# Product Quality Notice

Notice number: PQN-2

Affected product: GB142 Gas Condensing Boiler

Subject: Quality Improvements on Spare Parts

Figure 1

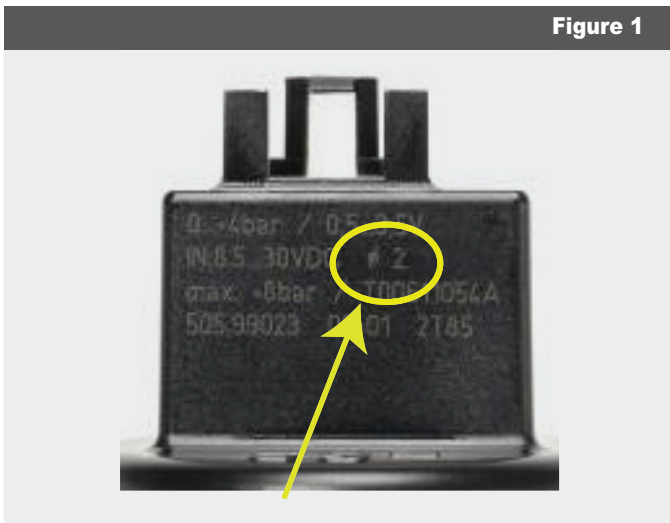
- **Problem description:**  
Due to dirt accumulating in the measuring hole of pressure sensor, the failures "2L-266/328" and "CO -288" can occur on the display.
- **Product Improvement:**  
Diameter of measuring hole increased from 0.9mm to 2.0mm. The new pressure sensor can be recognized by the  $\varnothing 2$  sign on the spare part (see Fig. 1).

- **Effective Date:**  
New Sensor included with boiler starting June 1st 2009.  
New Sensor available as a spare part starting June 1st 2009.

Figure 2

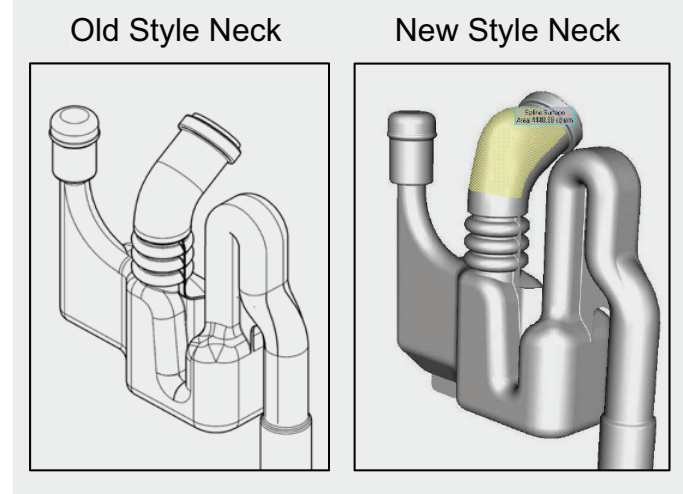
- **Problem description:**  
If condensate traps dry out the plastic may crack at the neck. Difficulty removing the trap for maintenance may also unintentionally lead to stress cracking.
- **Product Improvement:**  
Material changed to Bralen RB 03-23 known for high environmental stress cracking resistance. Neck design changed to allow ease of removal and prevent unintentional cracking through handling (See Fig. 2).

- **Effective Date:**  
Material change – June 2007  
Neck Design change – April 2008
- **Field Inventory Action:**  
Any condensate traps currently in field inventory with an FD < 7151 (see Fig. 3, how to read FD) may be returned for a replacement. Please call customer service to obtain an RMA. Photo identification of the FD number will be required for credit.
